ENVIRONMENTAL IMPACT REPORT

An Addendum to the Draft
Environmental Impact Report

Grizzly Peak Estates
ER 79-23

City of Oakland

REVISED STREET CROSS SECTIONS
(See revised Tentative Map)

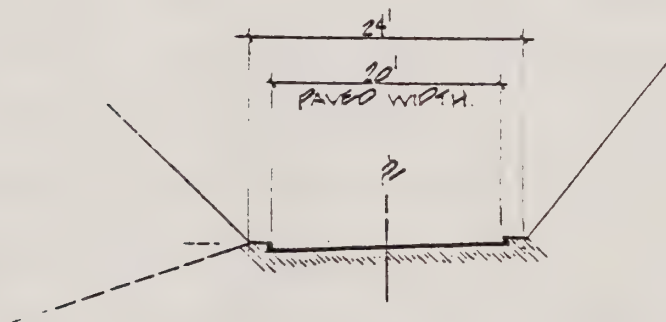
Comment: Public Works commented that the subdivision streets should be made wider to provide for on-street parking and better emergency vehicle access.

Response: The revised Tentative Map includes new lot and subdivision street configurations, including a wider loop-street serving most of the lots (40 feet of public right-of-way with 28 feet of paving width).
